# Service Manual

*Supplement*

**KX-TS2388CAB/KX-TS2388CAW/  
KX-TS2388RUB/KX-TS2388RUW/  
KX-TS2388UAB/KX-TS2388UAW/  
KX-TS880B/KX-TS880W/  
KX-TS880LXB/KX-TS880LXW/  
KX-TS880MLW/KX-TS880MXB/  
KX-TS880MXW/KX-TS880NDB/  
KX-TS880NDW/KX-TS880SAW/  
KX-TS881MXB/KX-TS881MXW/  
KX-TS889MXW/KX-TS108W**

Integrated Telephone System

### 3.1.5. KX-TS880MX

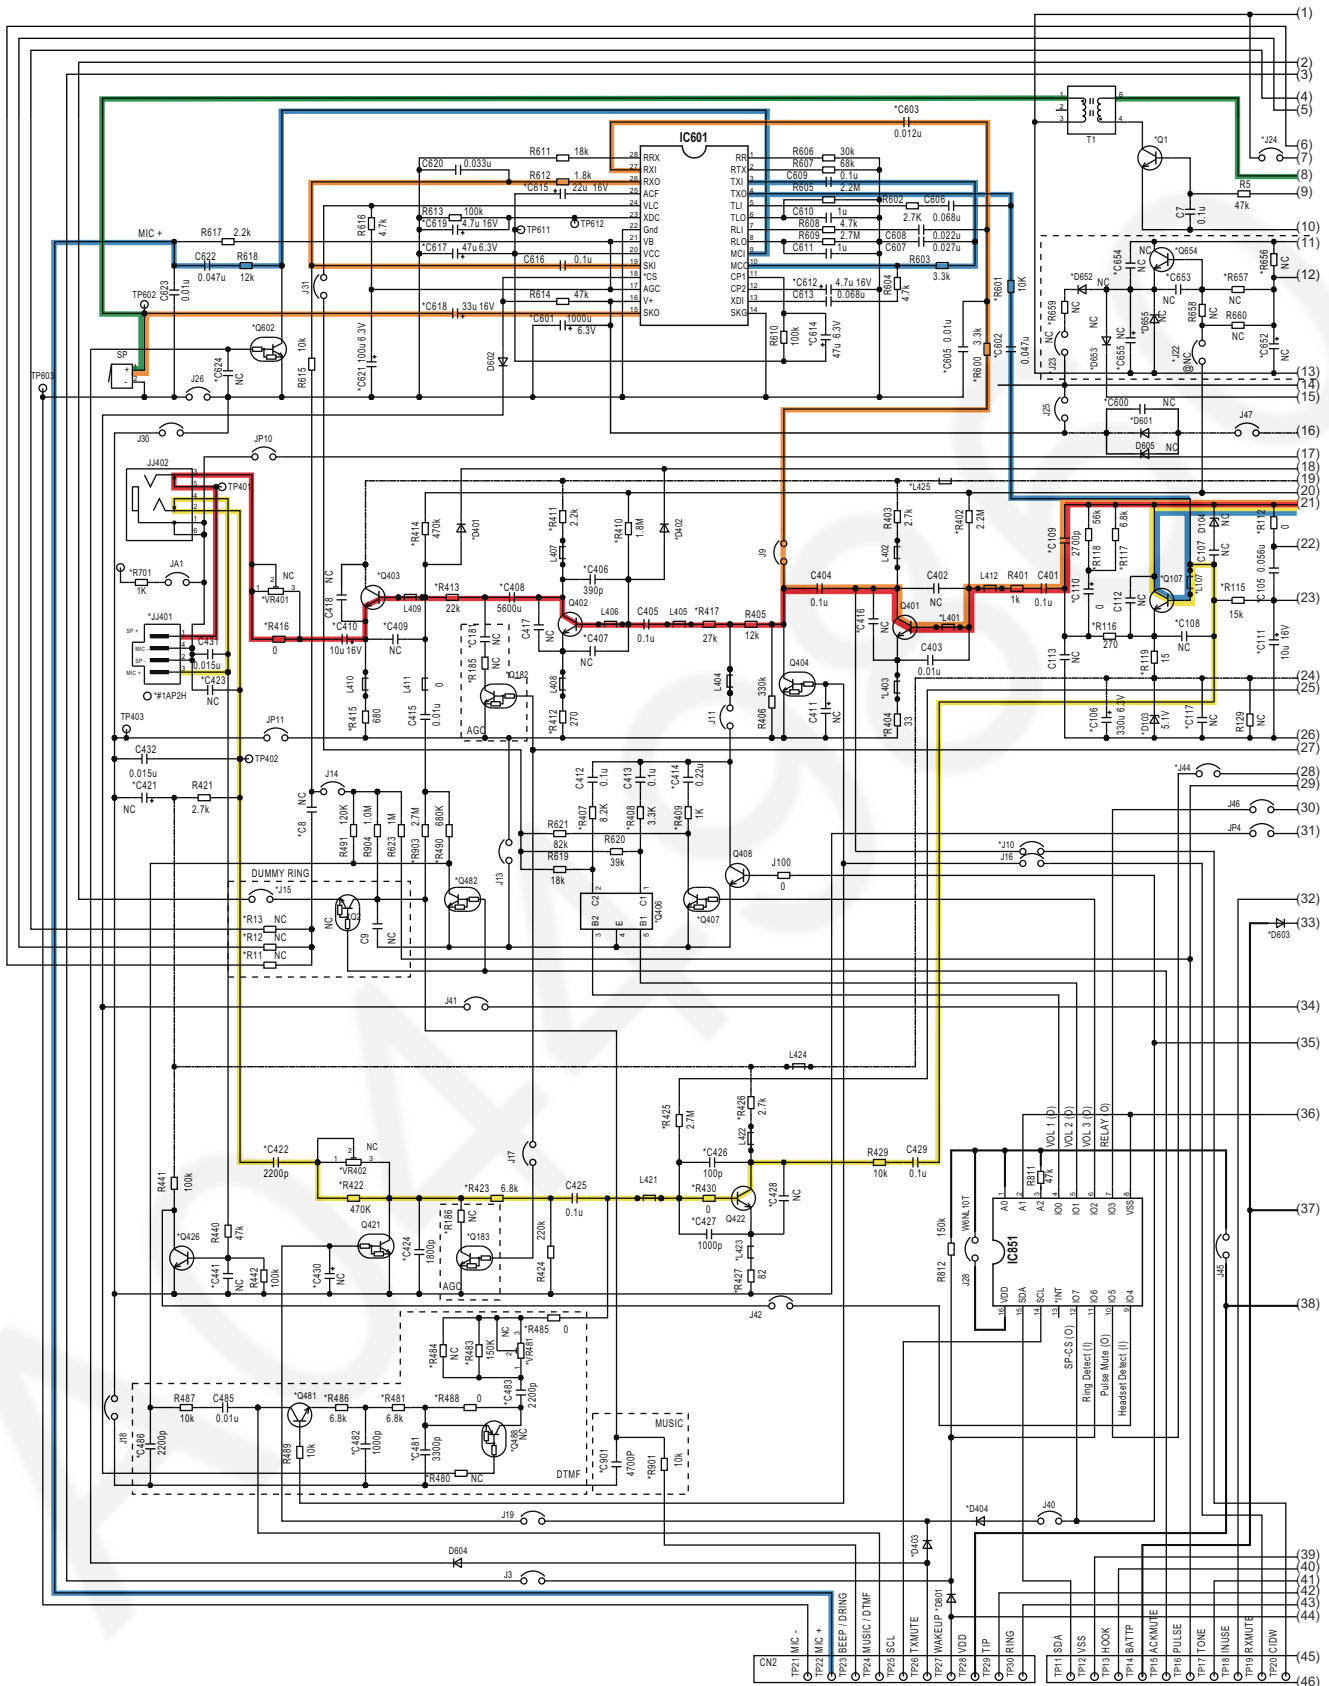
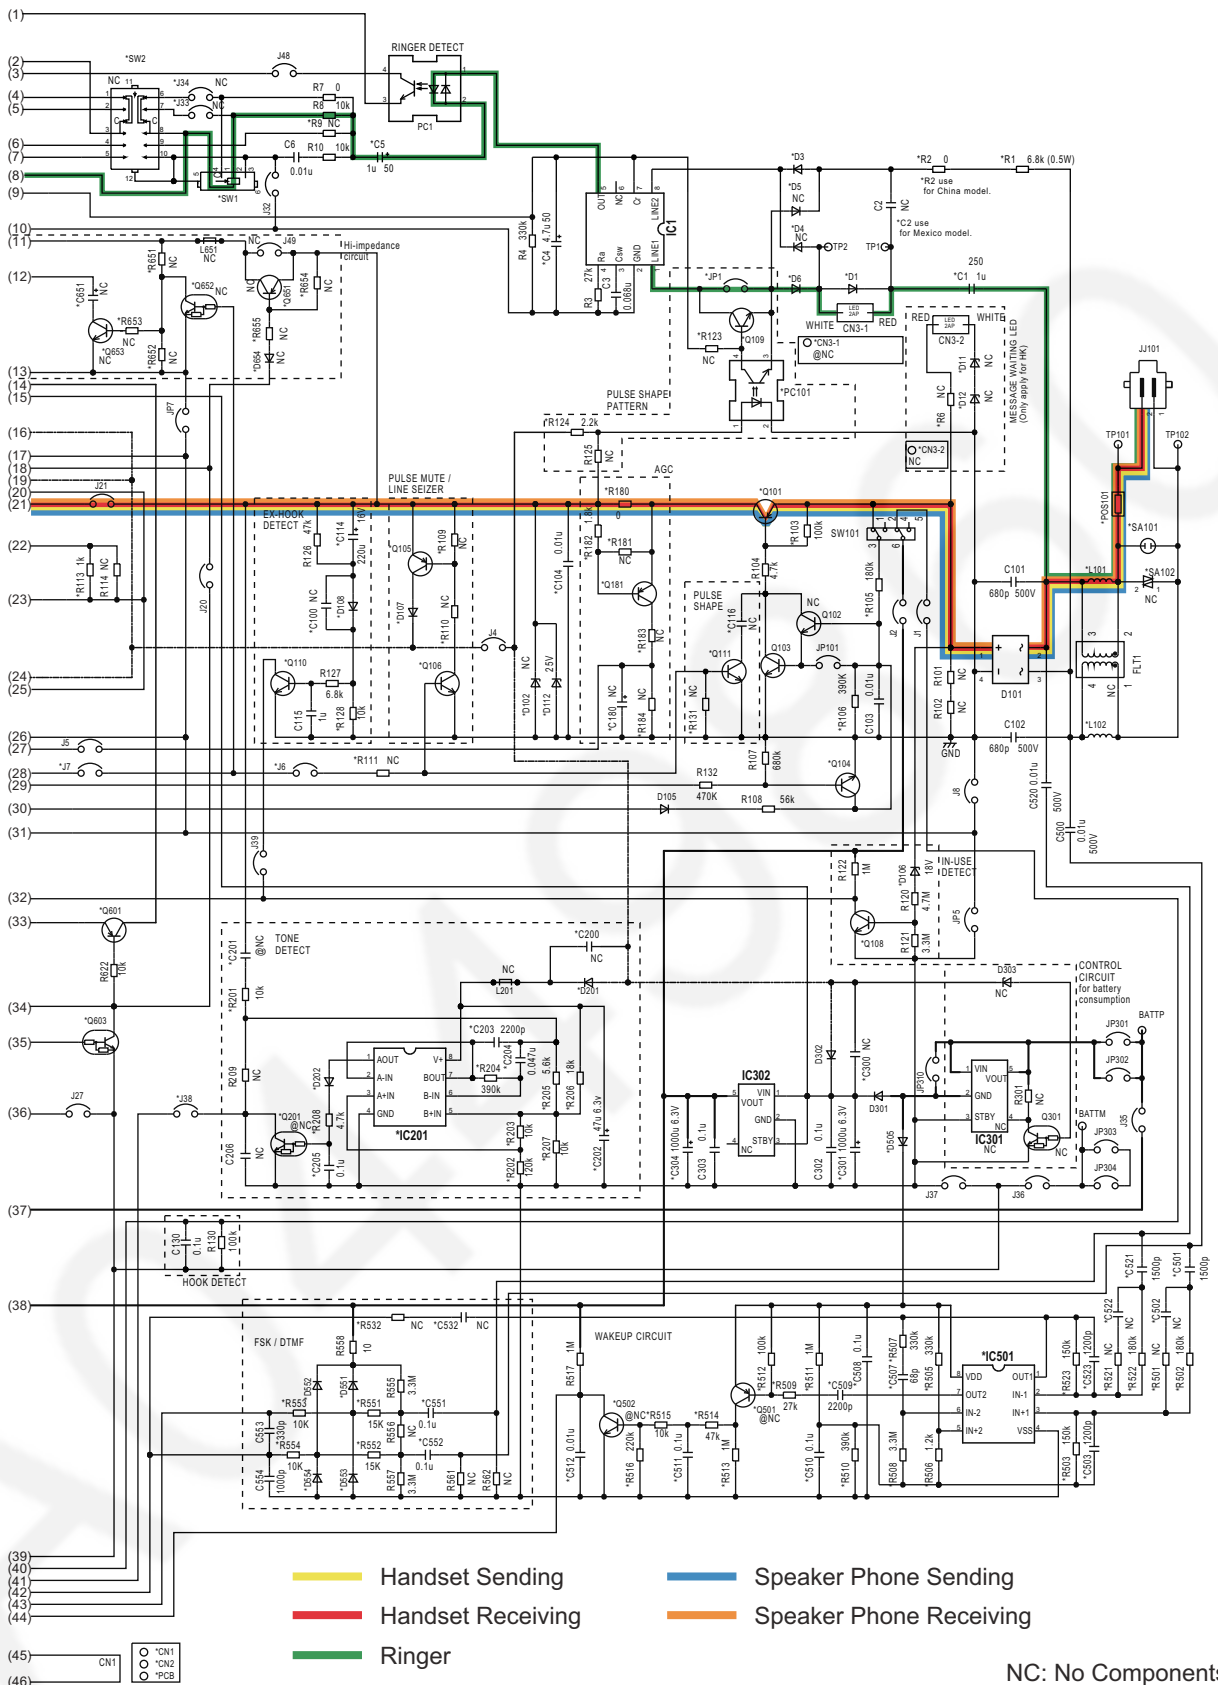
[Changed from original section "11.2. Schematic Diagram (Main)"]

KX-TS880 SCHEMATIC DIAGRAM (Main)

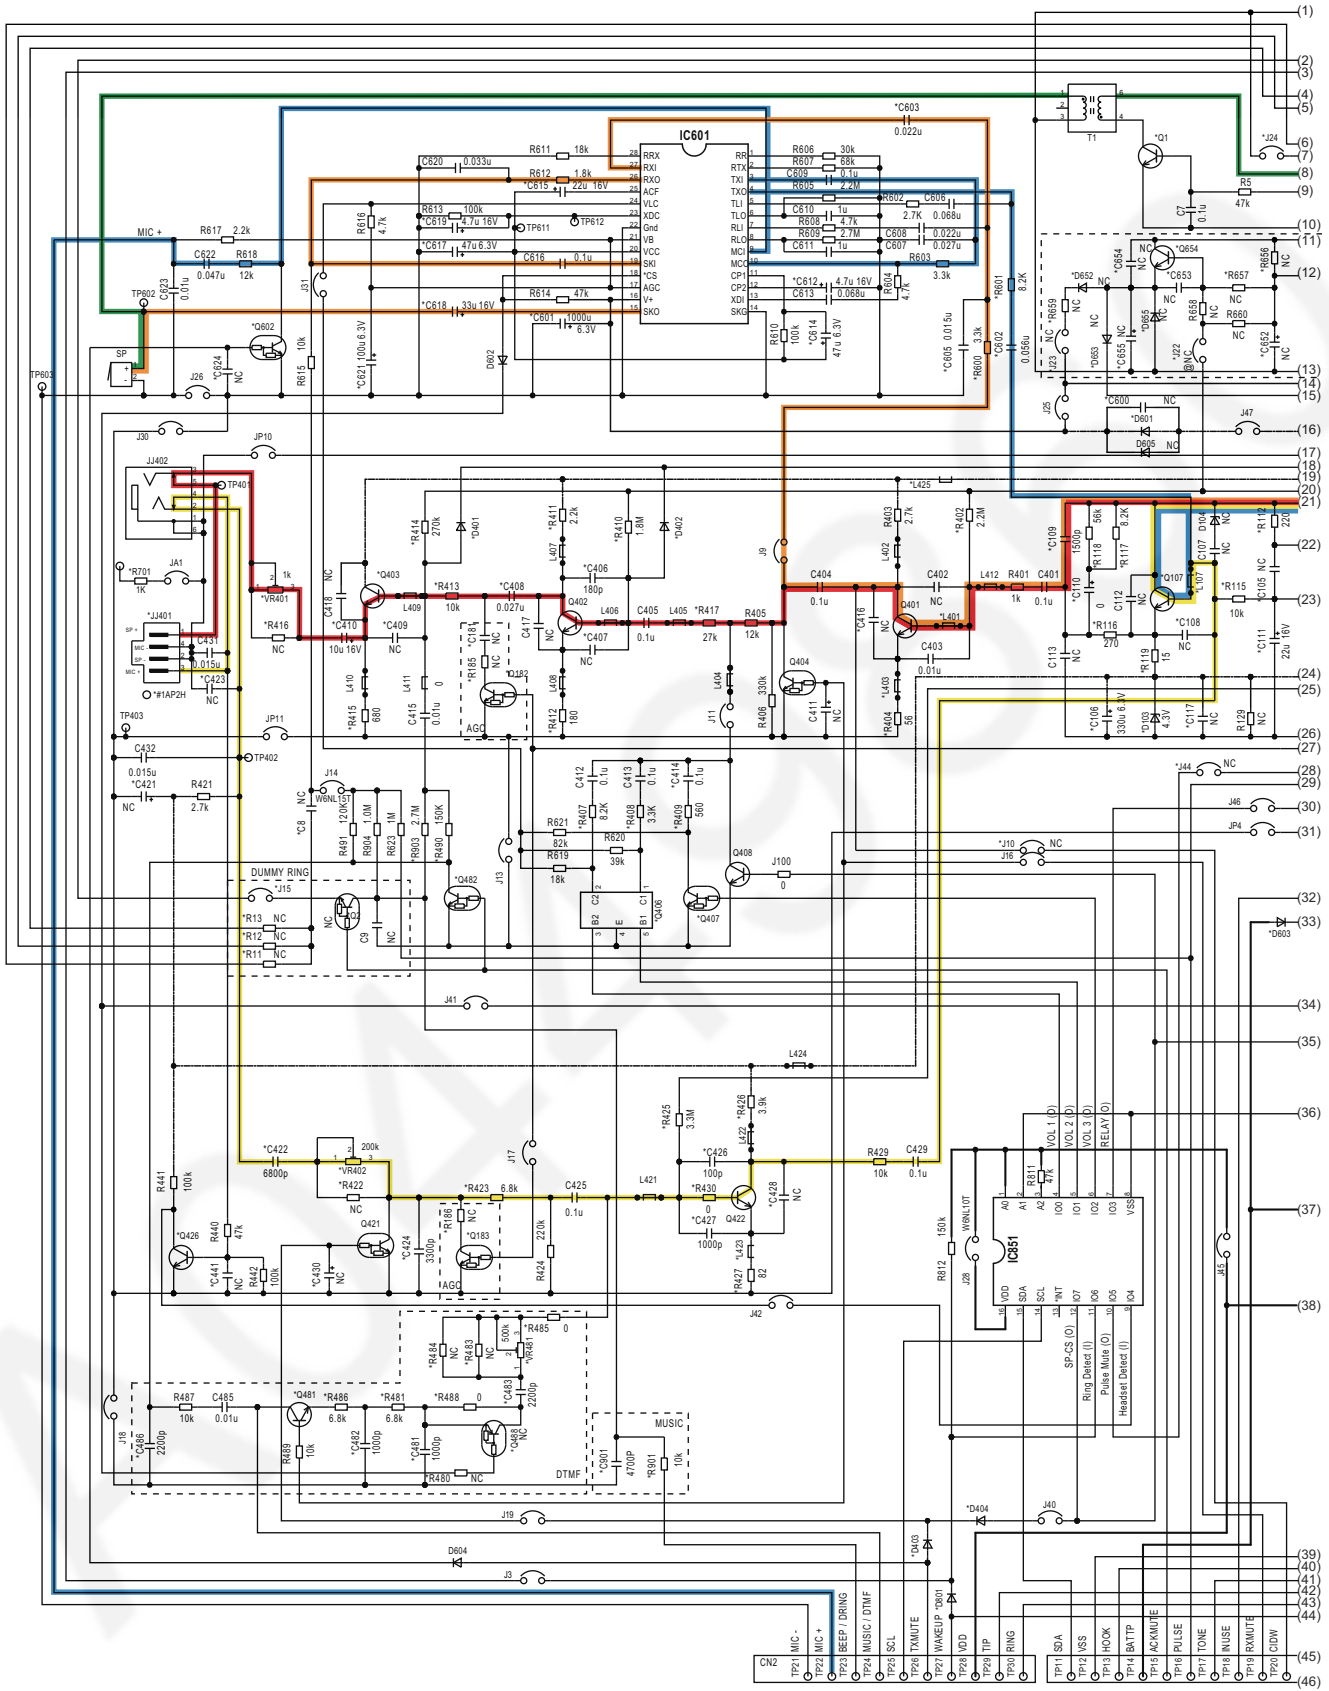
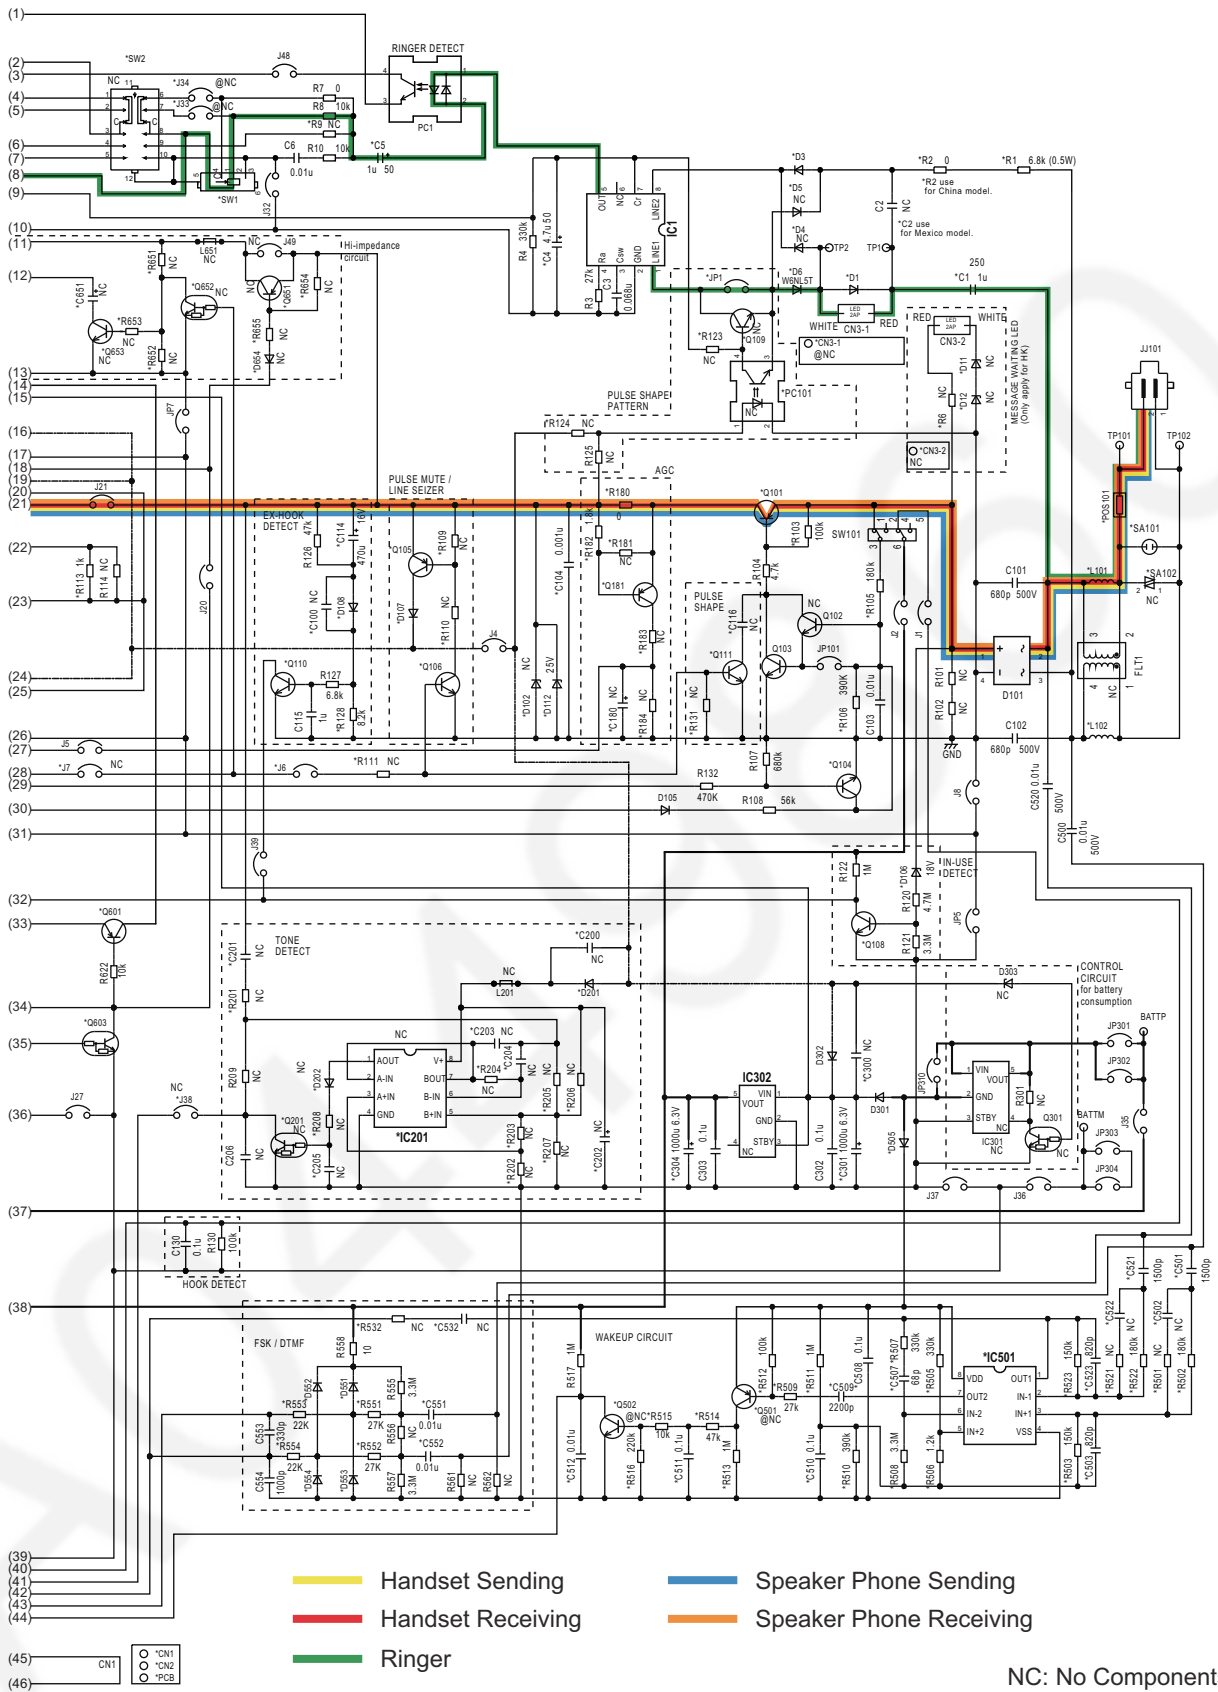
[Changed from original section "11.2. Schematic Diagram (Main)"]
